California Department of Transportation

Rancho Guejito Wine Tasting Facility and Event Center
MND/ SCH# 2022120692

Caltrans has the following comments:

Driveway Design Requirements for Rural Areas with Unimproved Frontage on Conventional State Highways

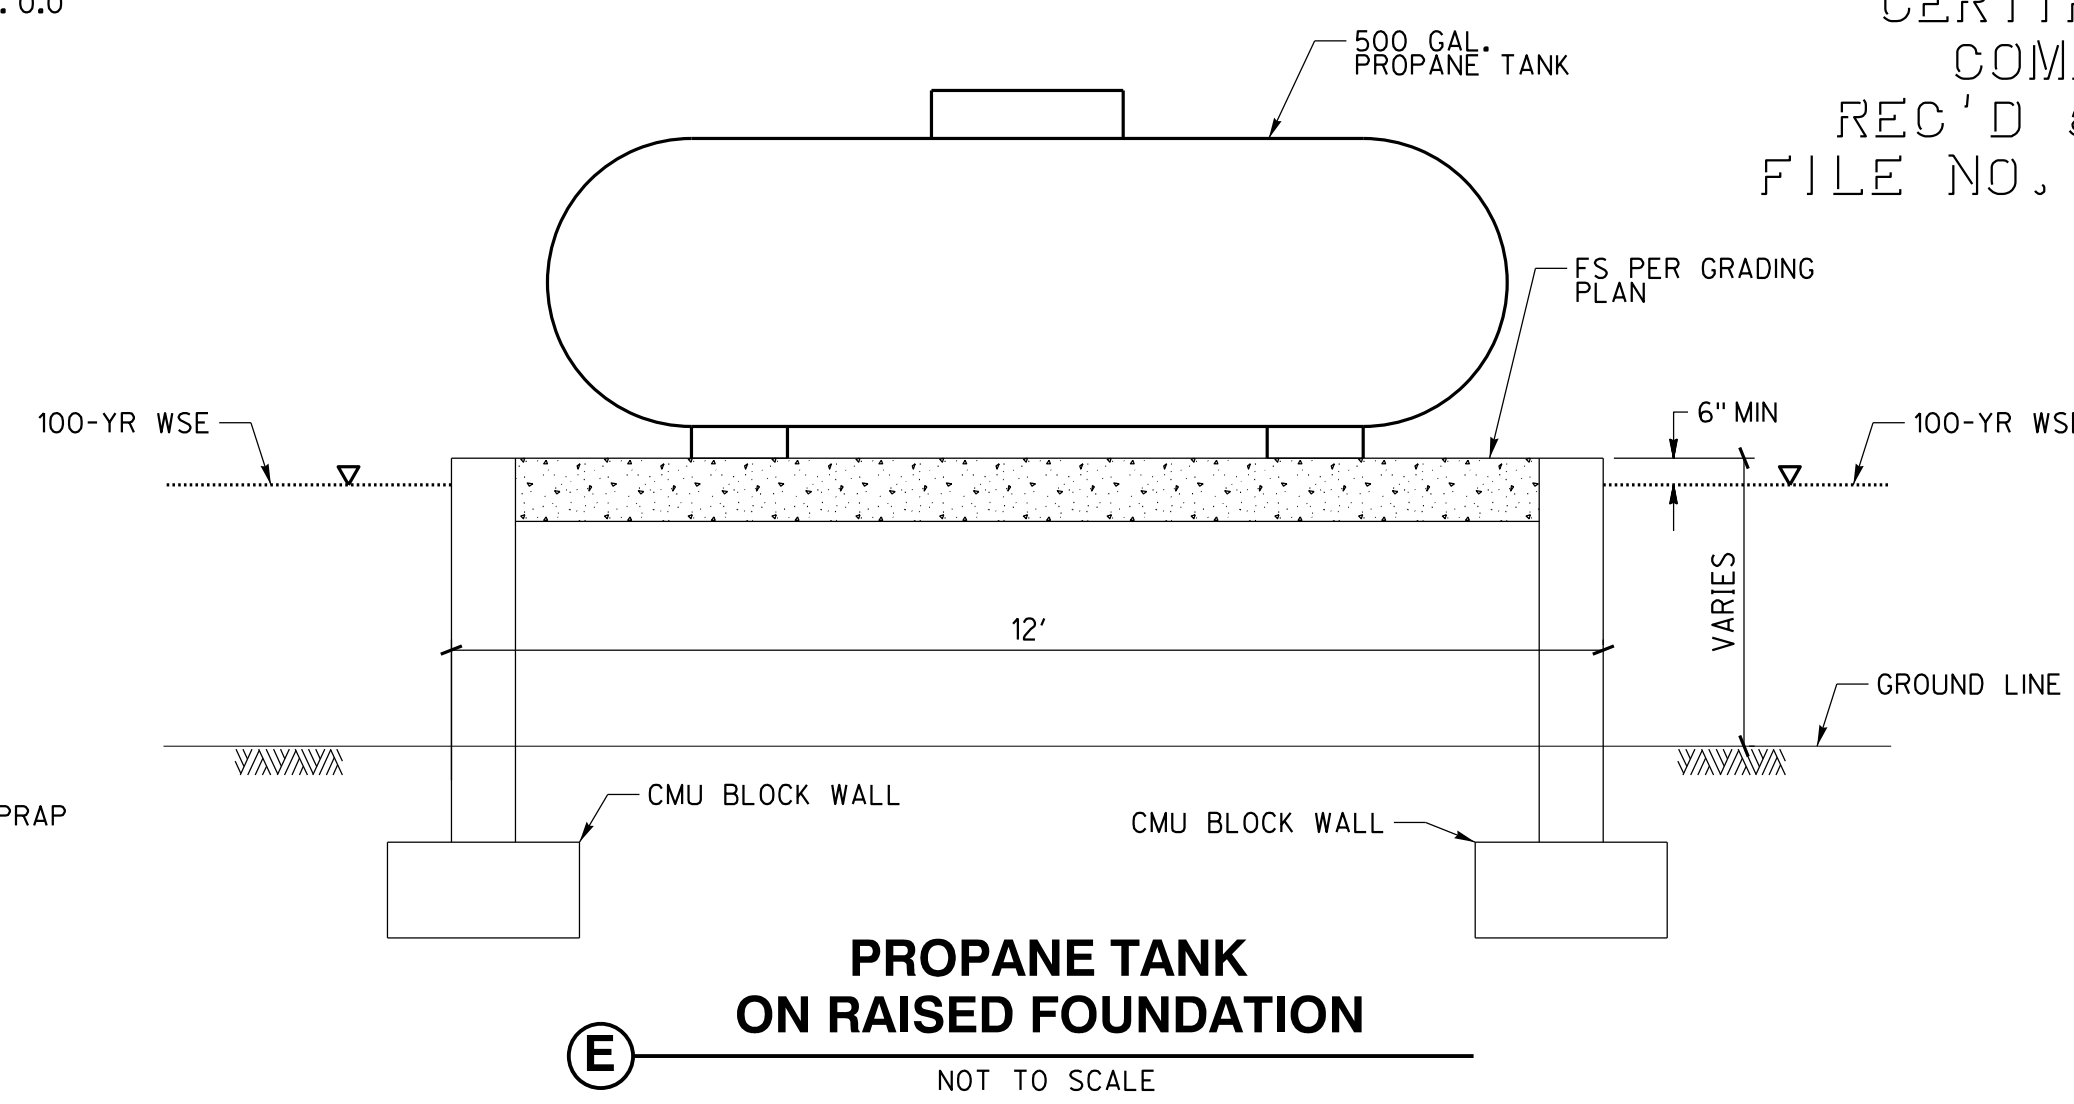
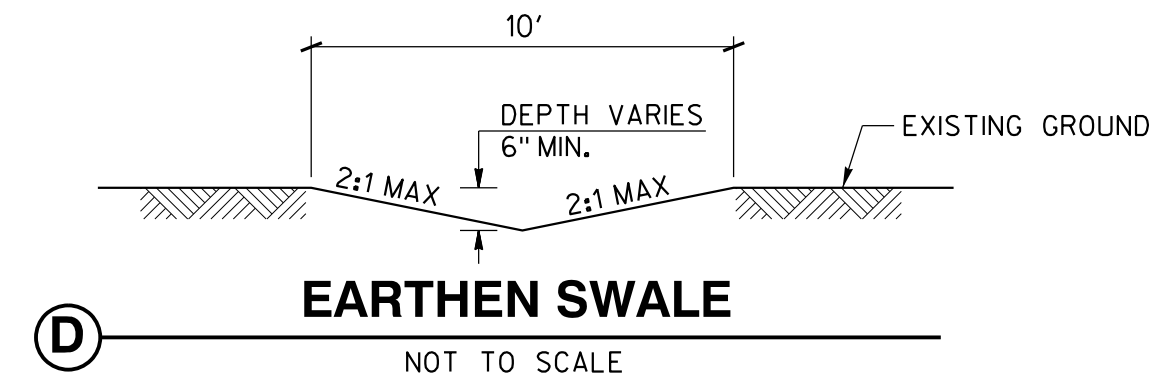
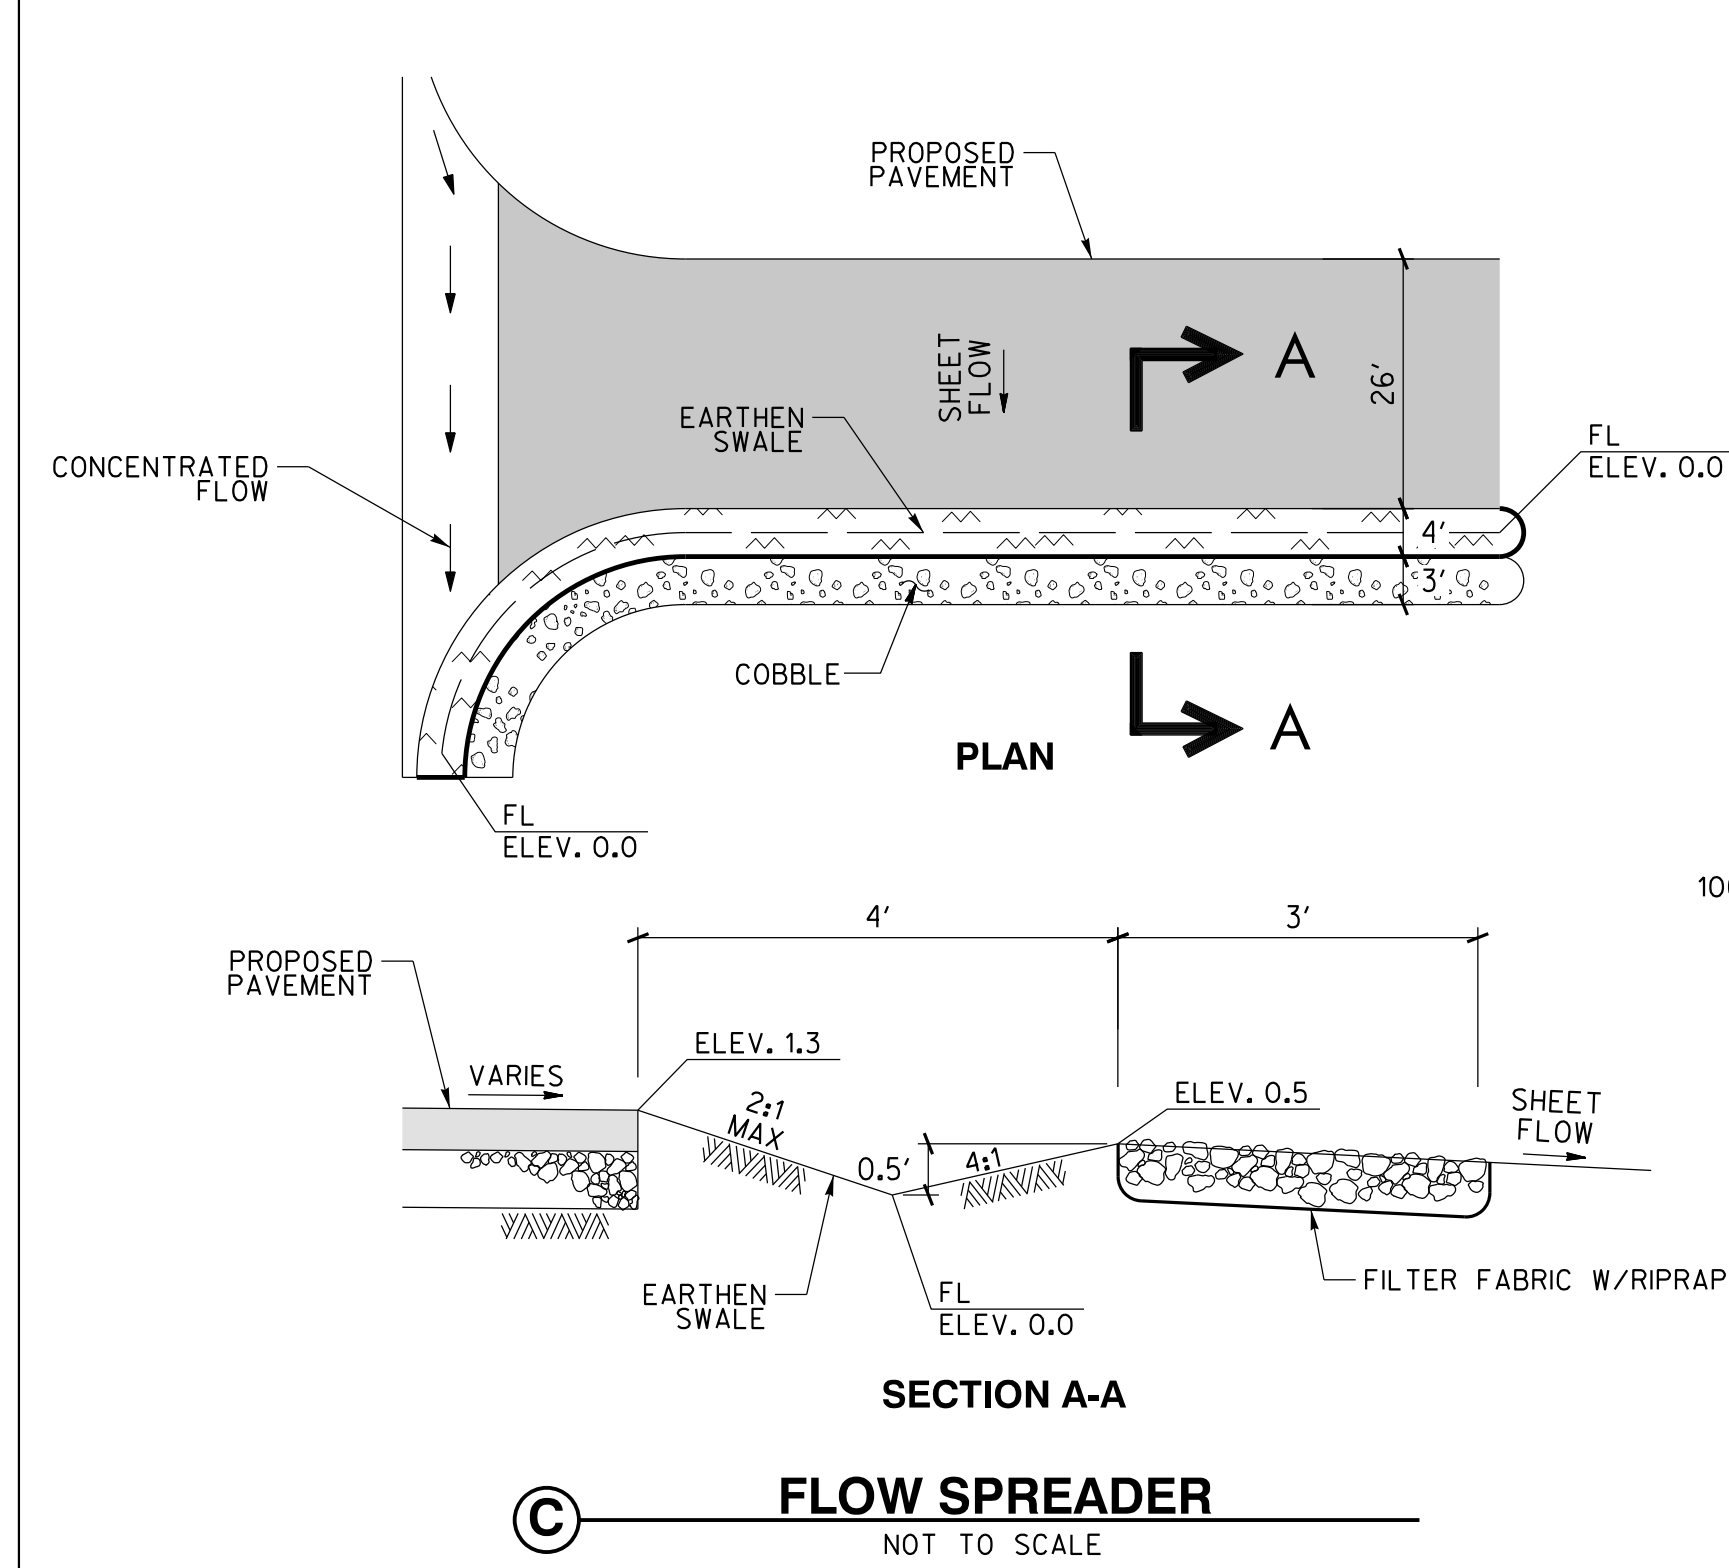
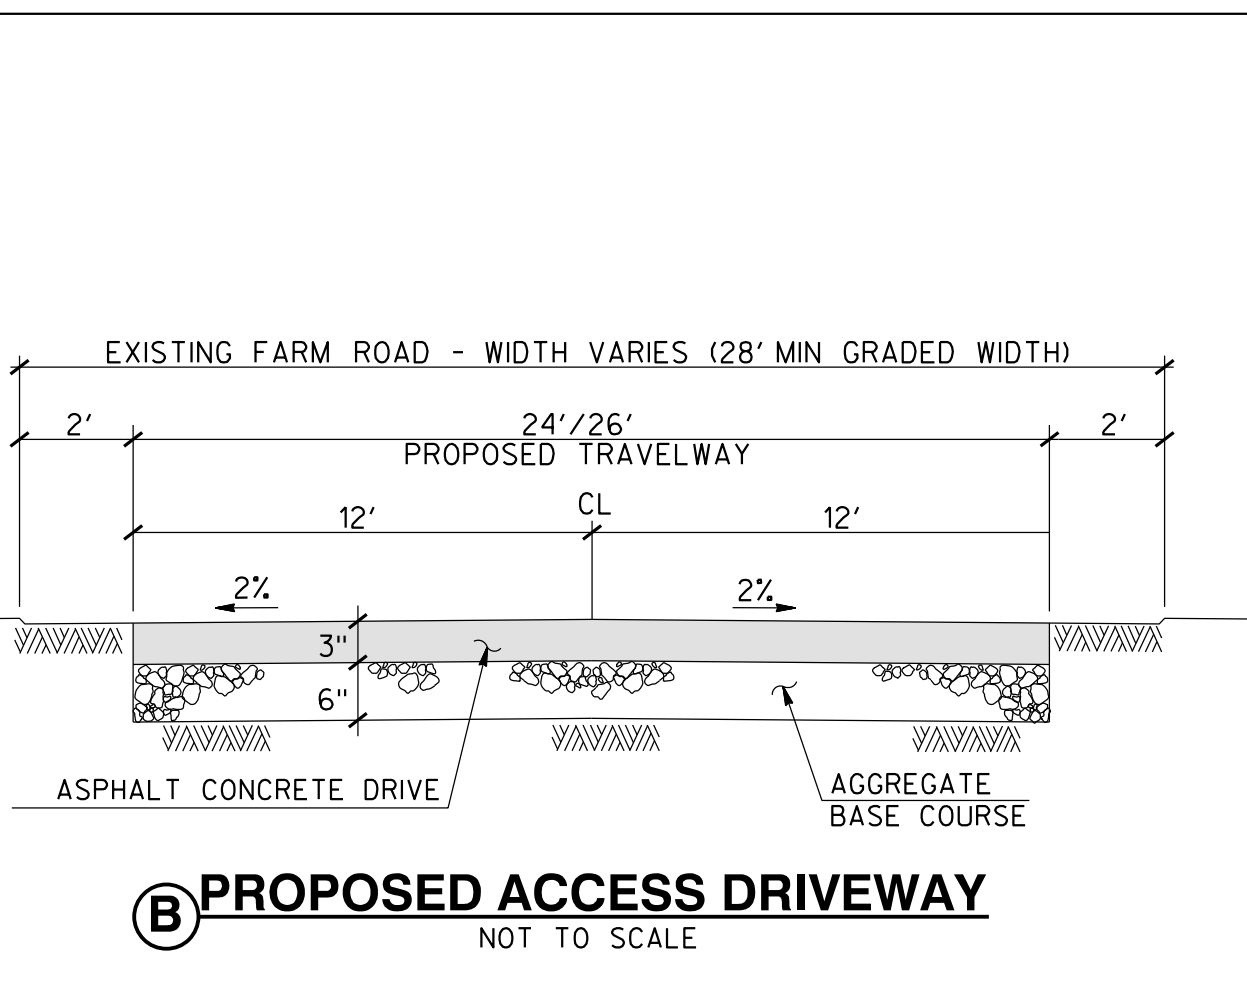
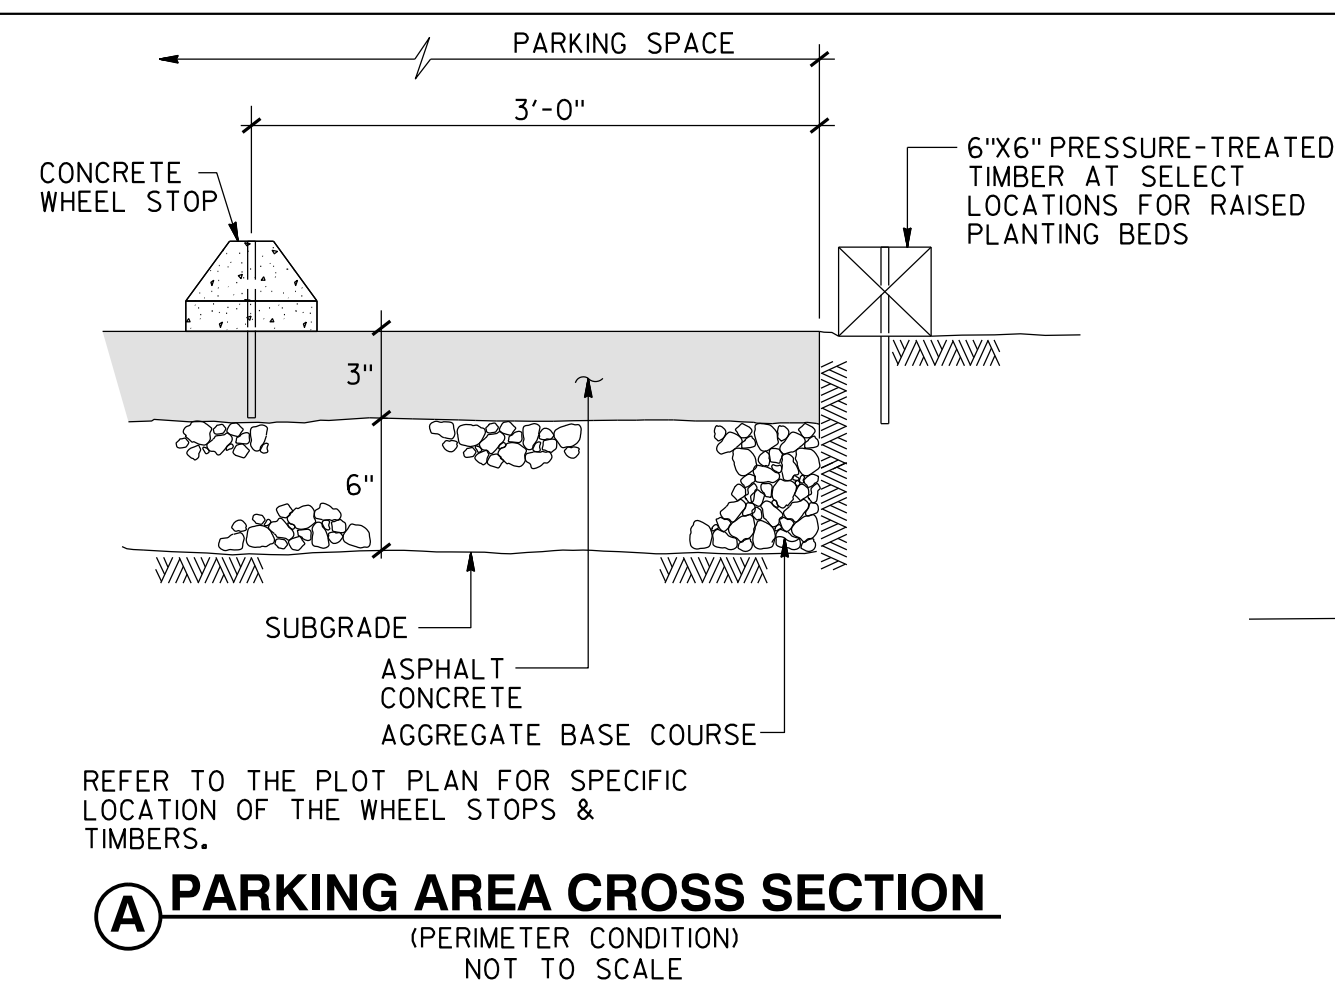
- The location of the driveway shall be designed to maximize corner sight distance. For corner sight distance, see the Caltrans Highway Design Manual (HDM) Index 405.1(2)(c). Driveway proposals that do not meet sight distance requirements will not be permitted. The minimum corner sight distance shall be equal to the stopping sight distance as given in HDM Table 201.1. HDM Table 101.2 shows appropriate ranges of design speeds that shall be used for the various types of facilities, place types, and conditions listed. (See HDM Table 101.2 Vehicular Design Speed; Table 201.1 Sight Distance Standards; Index 205.4 Driveways on Frontage roads and in Rural Areas; Index 405.1 (2) Corner Sight Distance).

- Driveways connecting to State highways shall be paved a minimum of 20 feet from the edge of shoulder or to the edge of State Right-of-Way (R/W), whichever is less to minimize or eliminate gravel from being scattered on the highway and to provide a paved surface for vehicles and bicycles to accelerate and merge. Where larger design vehicles are using the driveway (e.g., dump trucks, flatbed trucks, moving vans, etc.), extend paving so the drive wheels will be on a paved surface when accelerating onto the roadway (See HDM Index 205.4 Driveways on Frontage roads and in Rural Areas).

- Approach and departure tapers should be 50 feet longitudinal and 8 feet from edge of traveled way at the end of the taper. Approach and departure tapers are not required where the existing paved shoulder is at least 8 feet wide (See HDM Figure 205.1 Access Openings on Expressways).

- Approach and departure tapers should have structural sections matching the existing State highway shoulders. An alternate shoulder design is allowed. See Caltrans HDM Figure 613.4B for details. For asphalt driveway the structural section should be equal to or greater than edge of shoulder or approach and departure tapers. Minimum thickness of surface course is 0.35 foot. Aggregate base depth should match State highway shoulders. Details (cross section, etc.) for concrete driveways are shown on Standard Plan A87A. Minimum thickness at driveway shall be 4 inches for residential and 6 inches for J-1 commercial. (See HDM 613.4(2) Shoulders; Standard Plan A87A Curb and Driveways).

- Place shoulder backing from the edge of pavement (EP) to the hinge point (HP). Shoulder backing should be placed on a width of at least 2 feet from EP. For placement of shoulder backing thickness greater than 0.5 foot for slope repair; shoulder backing behind dikes; and where longitudinal drainage are present; see HDM for details. (See HDM Index 672 Shoulder Backing and HDM Figures 672.3 A through E).
- Where County Regulations differ from the State's, it may be desirable to follow County regulations (See HDM Index 205.4 Driveways on Frontage roads and in Rural Areas).

*Corner Sight Distance shall be calculated from all directions of approach. See HDM Index 405.1(2) & Figure 405.7 for set back and sight distance calculations.
